MISSISSIPPI POWER & LIGHT COMPANY

SUBJECT: Grand Gulf Nuclear Station
Units 1 and 2
Docket Nos. 50-416 and 50-417
File 0260/0862
Transmittal of Proposed FSAR
Changes and Responses to NRC
Questions
AECM-81/277

MISSISSIPPI POWER & LIGHT COMPANY
GRAND GULF NUCLEAR STATION
UNITS 1 & 2
FINAL SAFETY ANALYSIS REPORT

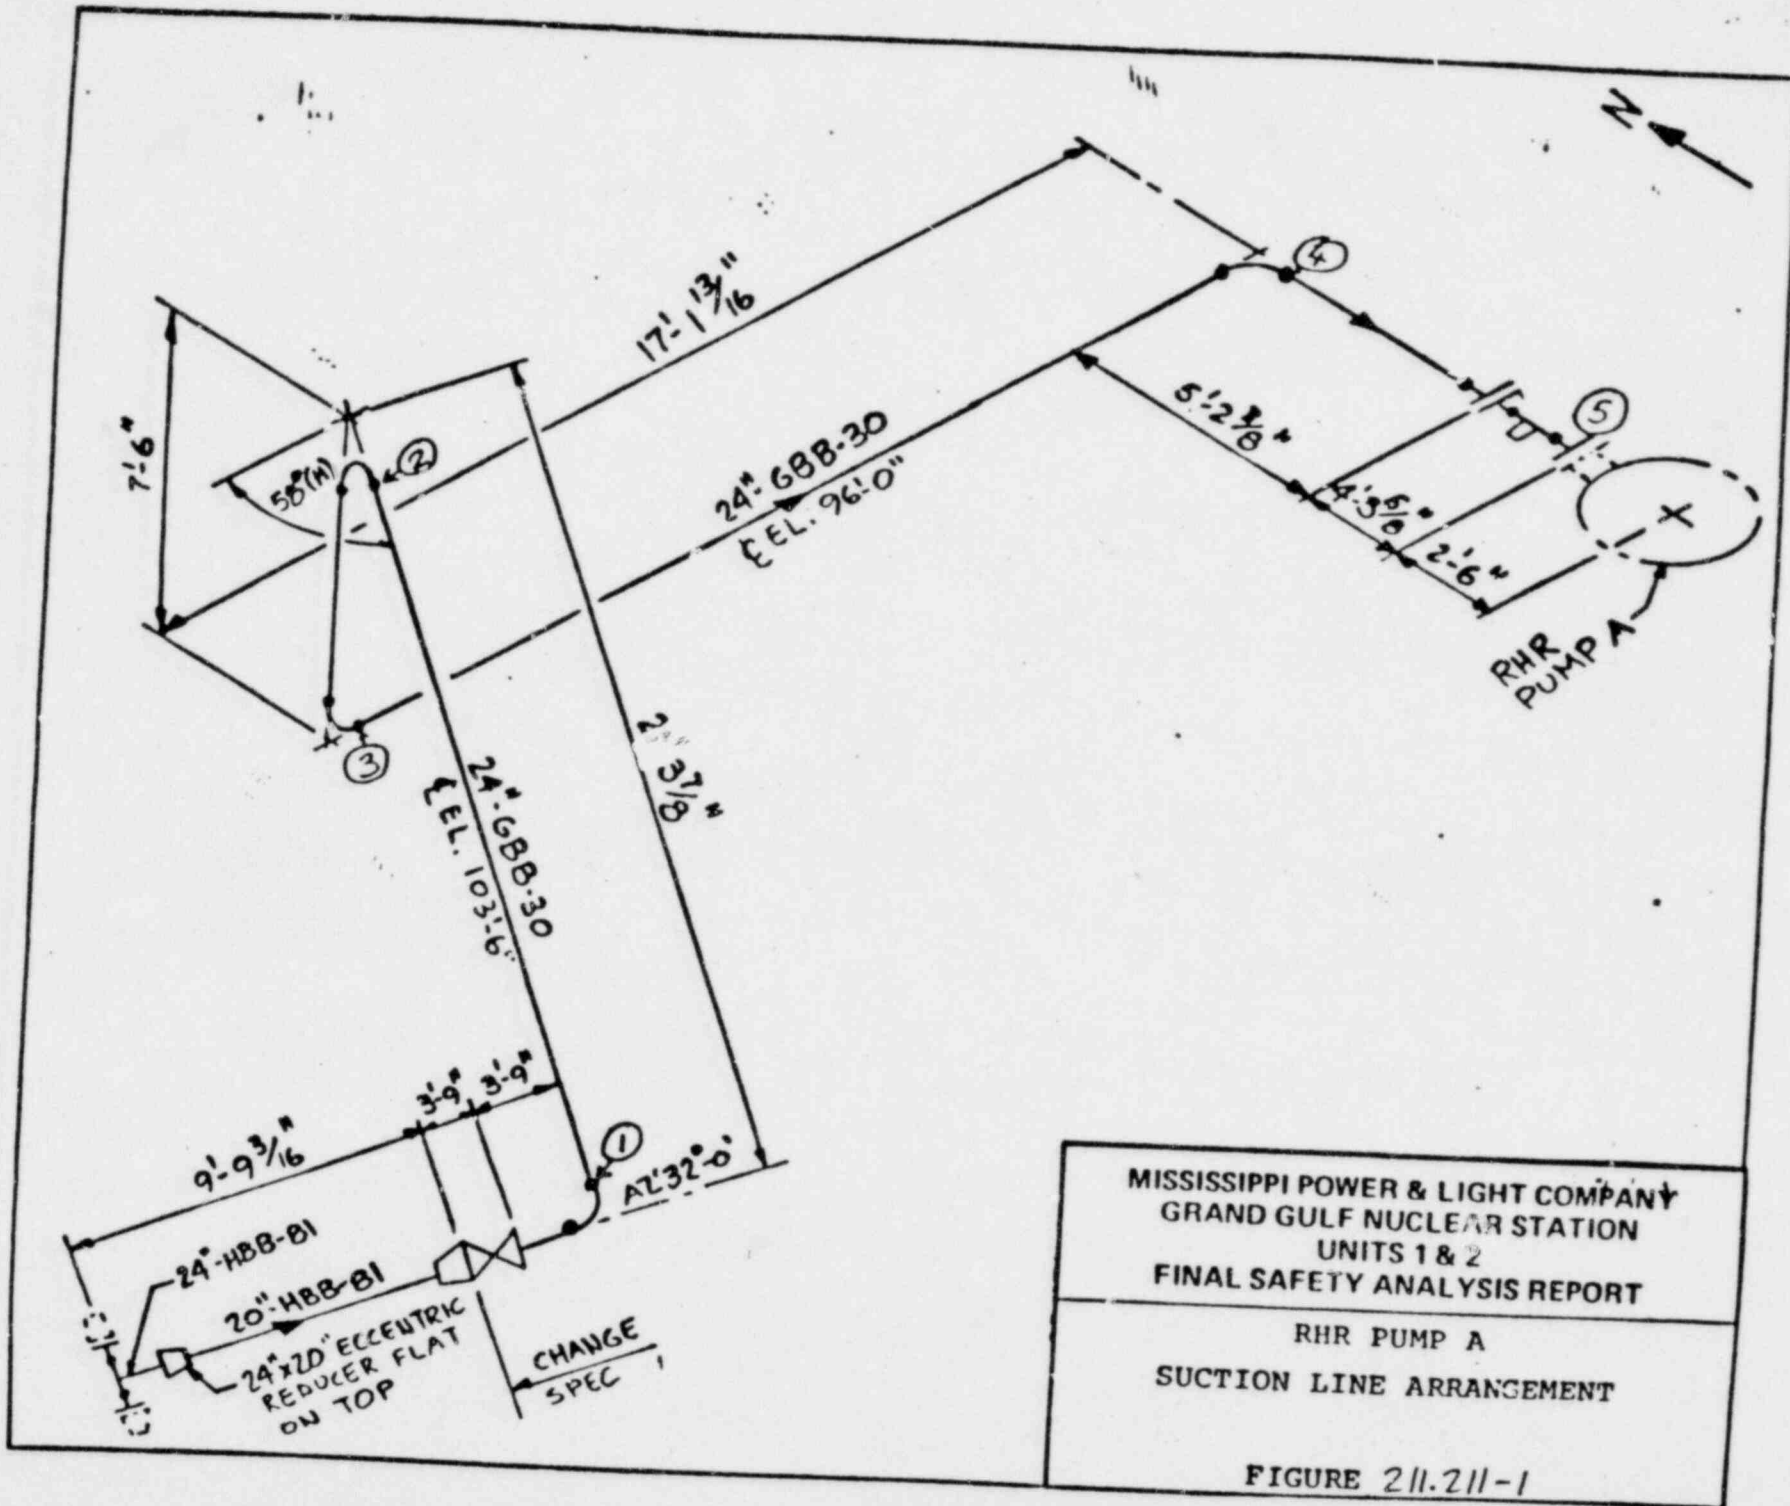
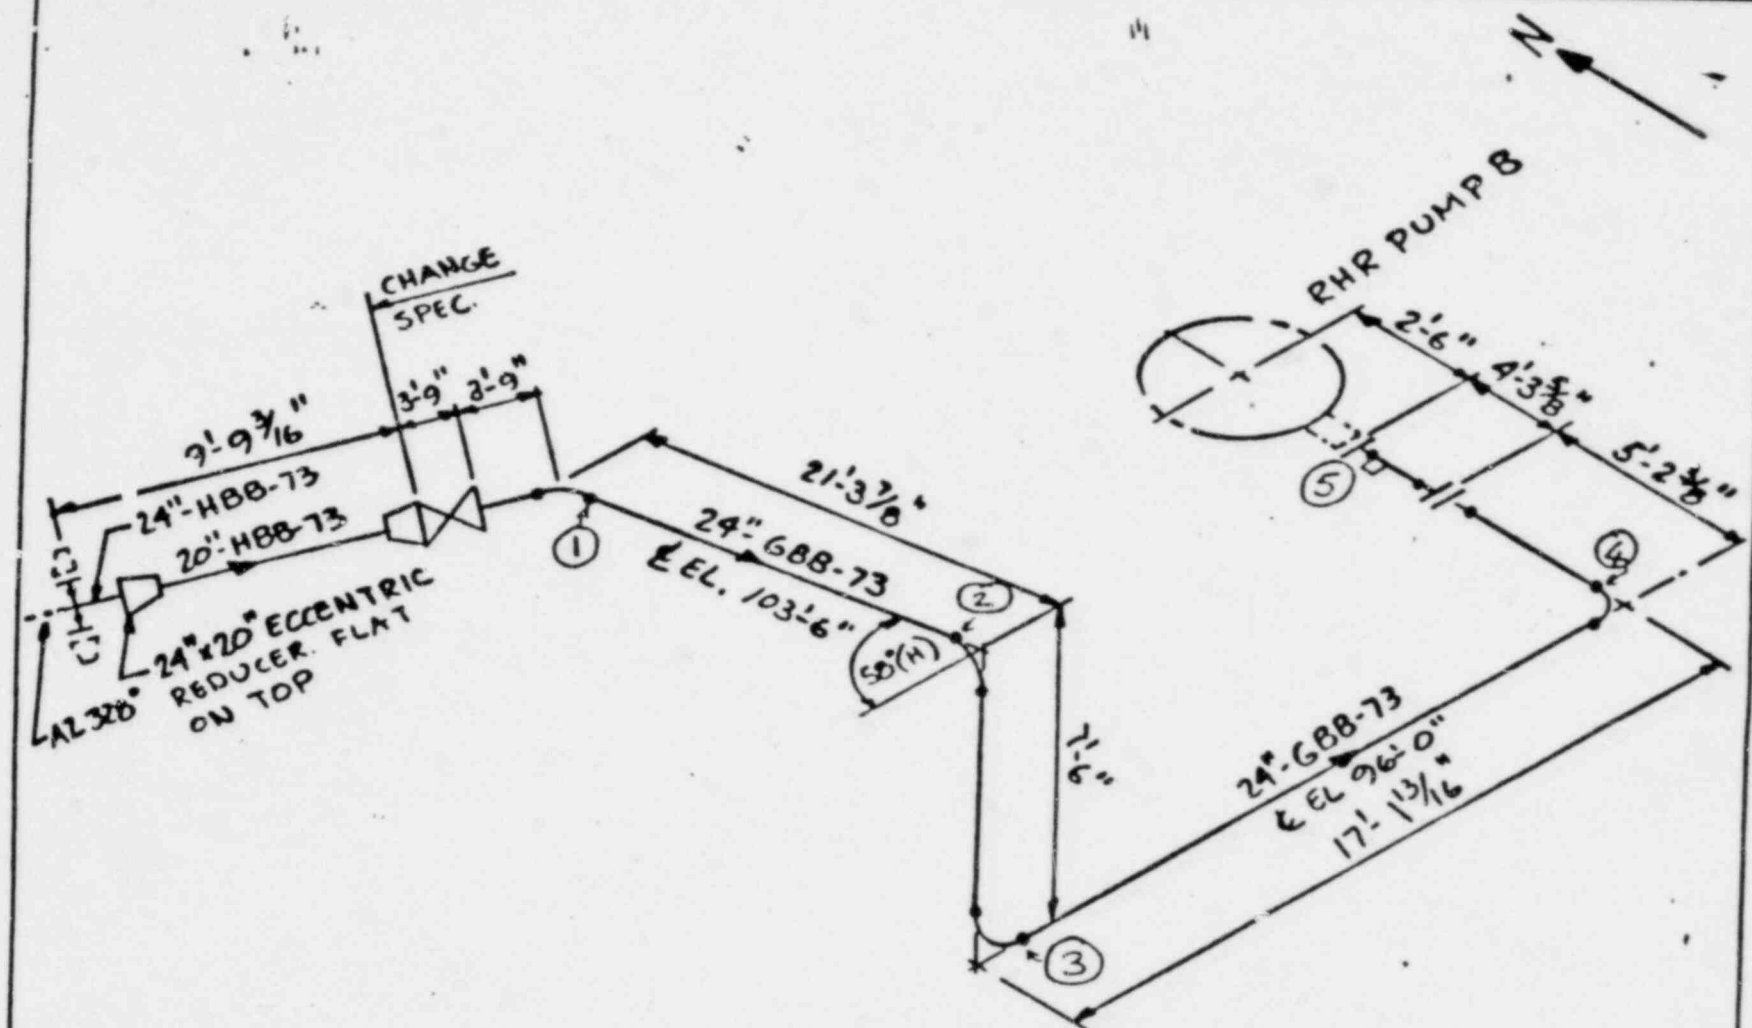
211.211 Calculations of NPSH available to ECCS pumps in BWRs are normally provided with reference to the pump suction. We are concerned that under certain post accident conditions the potential may exist for damage to ECCS pumps from cavitation because of local flashing in the system suction lines. The potential can result for example from local elevation changes in the piping runs. Calculations of NPSH available at the pump suction may erroneously assume liquid continuity up to the point of pump suction. We require therefore that the applicants provide calculations demonstrating that all points in all safety related suction piping, the NPSH available is adequate to preclude local flashing under the worst postulated conditions.

RHR "A" Pump

Reference Figure 211.211-1 (same as Figure 5.4-27 with the addition of data points) for suction line geometry.

Summary: The pressure at all points along the suction piping exceeds the vapor pressure (14.7 psia) at 212°F.

SETTLEMENT VS TIME
 UNIT 1
 TURBINE BUILDING
 FIGURE 2.5-75a

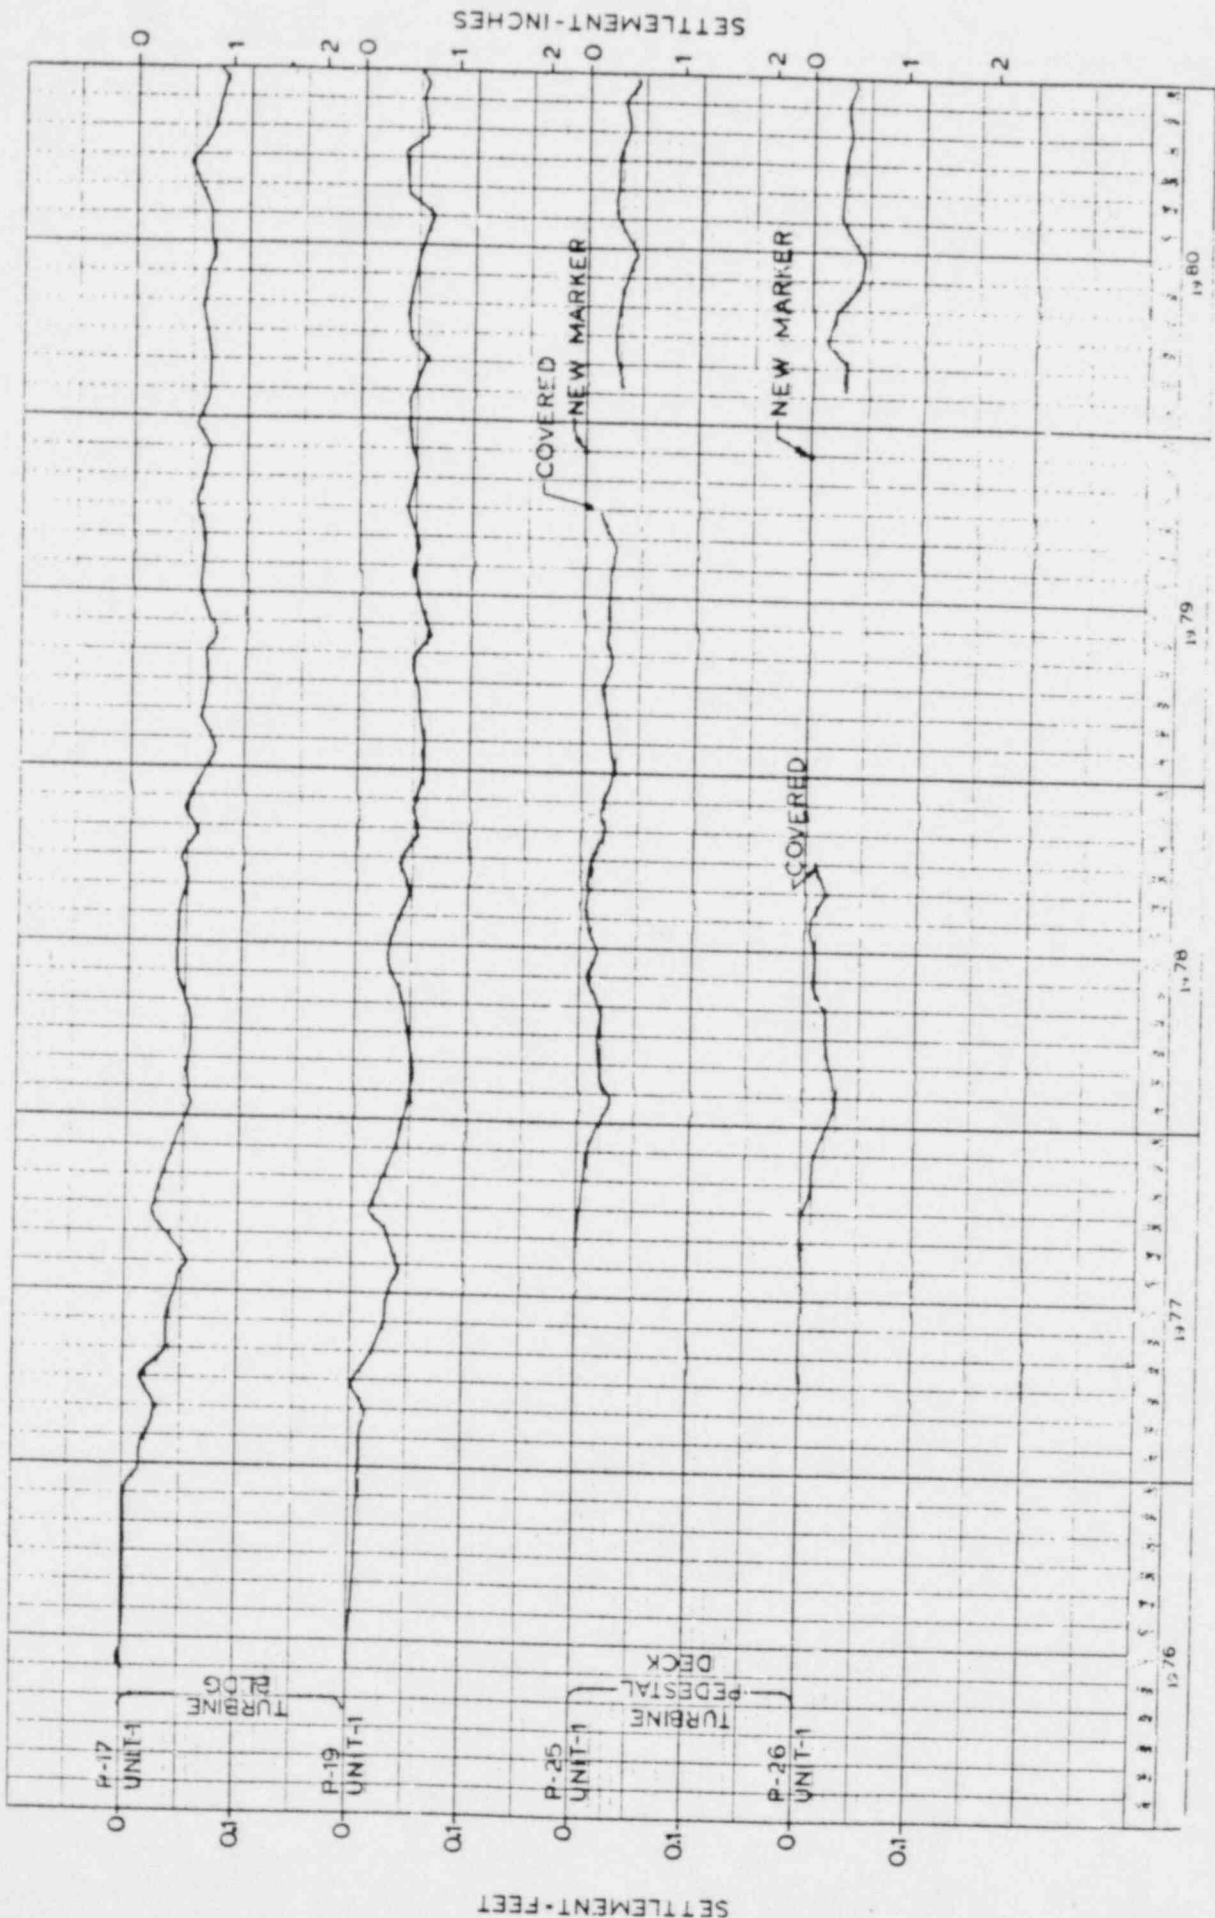
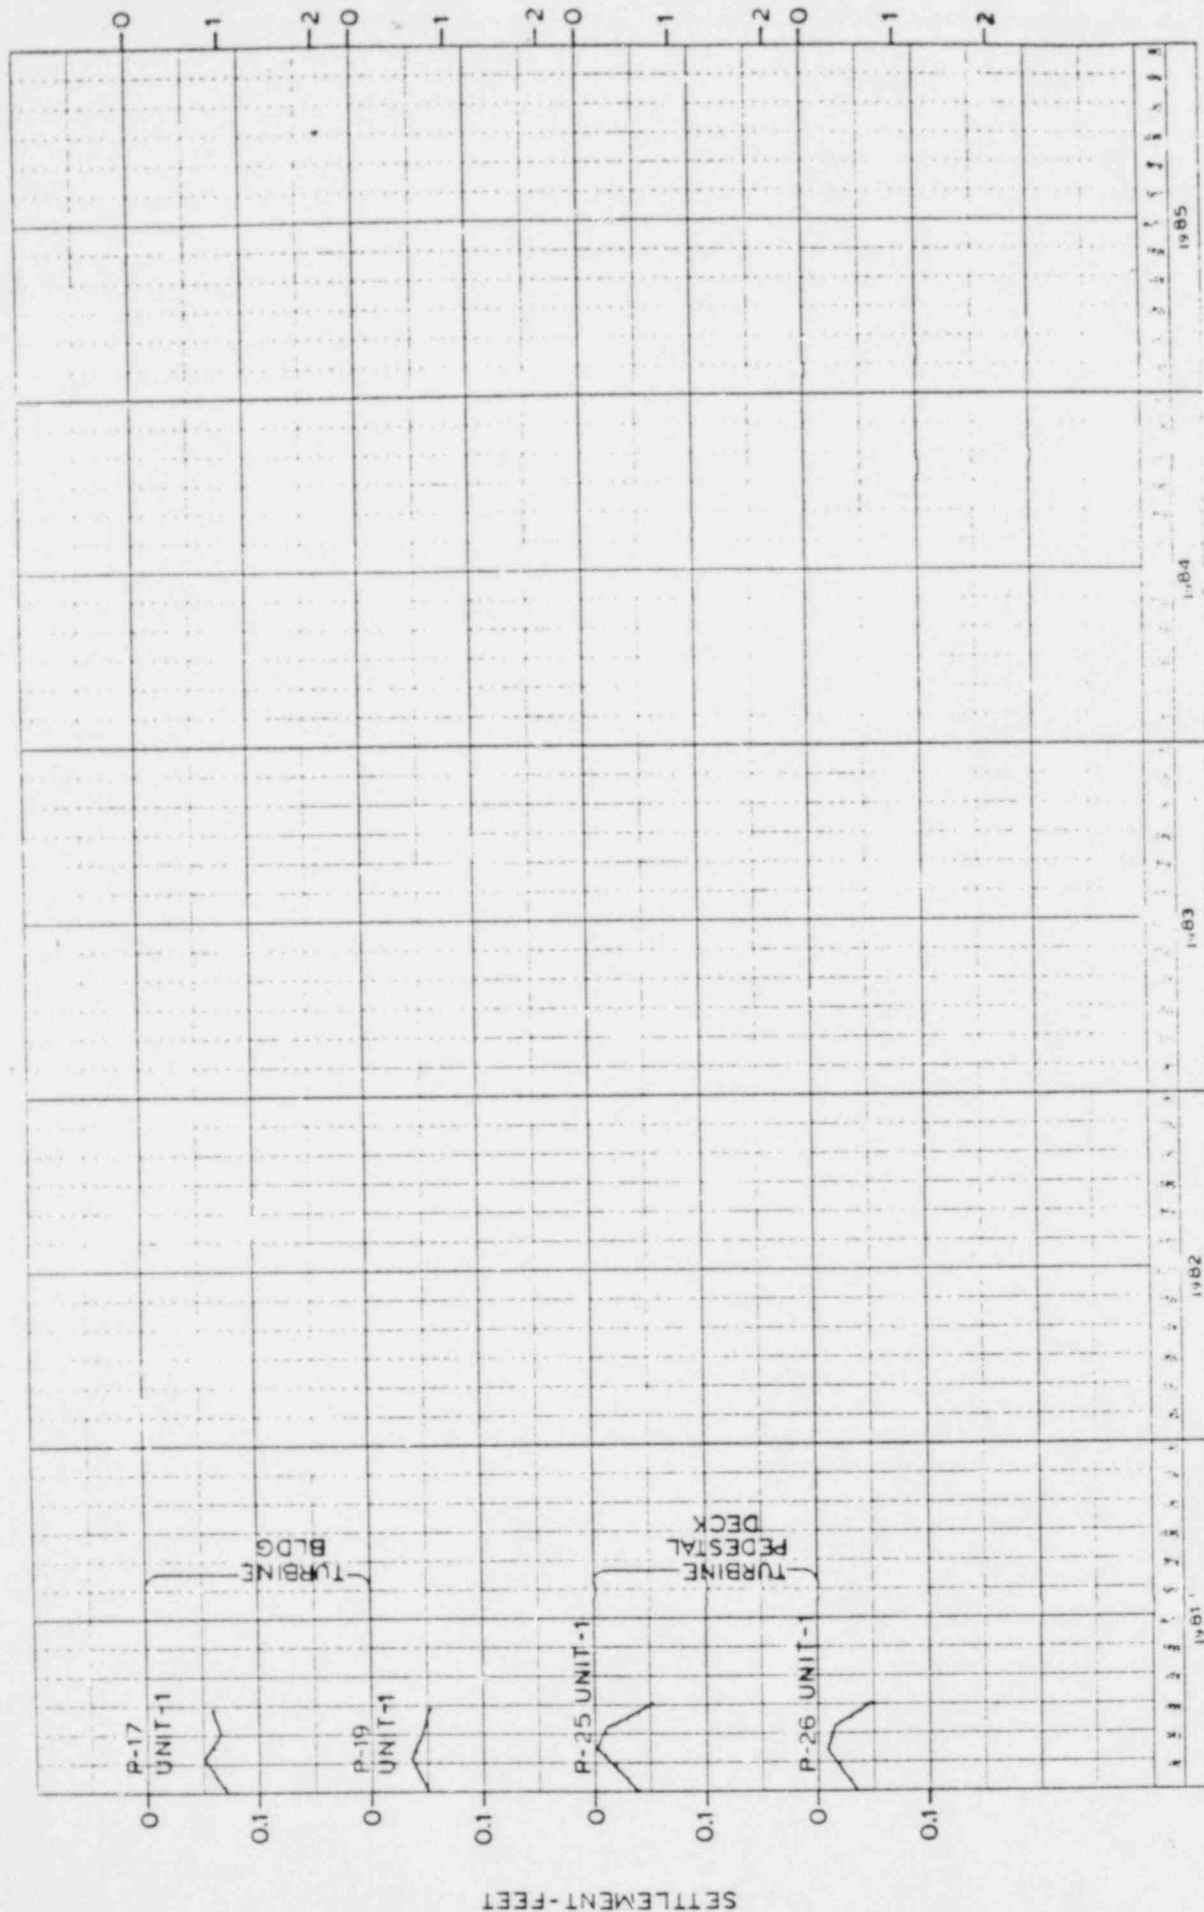
362.7
(2.5.4.13.1) Your response to NRC Question 362.5 (page Q&R 2.5-14, Amendment 30) is not complete. Indicate what measured value of differential settlement would cause code allowable stresses to be exceeded for individual buildings and buried piping and require notification of NRC. Provide a table of these values and the limiting stress criteria. Update the plots which show settlement recorded to date versus time; this is particularly important since construction of Unit 2 was still underway when your response to Question 362.5 was being developed.

The response to this question is given in revised subsection 2.5.4.13.1, revised Table 2.5-10 and revised Figures 2.5-75a through 2.5-75h.

The settlement markers will be read at one-month intervals until construction is complete and all pools are filled with water, at which time the results of the settlement monitoring program will be evaluated and long-term monitoring of the structures will be assessed. Total settlement will not be a Geotechnical concern until the following measured values are observed:

Turbine building	3"
Radwaste building	3"
Control building	3"
Containment building	3.5"
Auxiliary building	3.5"
Diesel generator building	3"
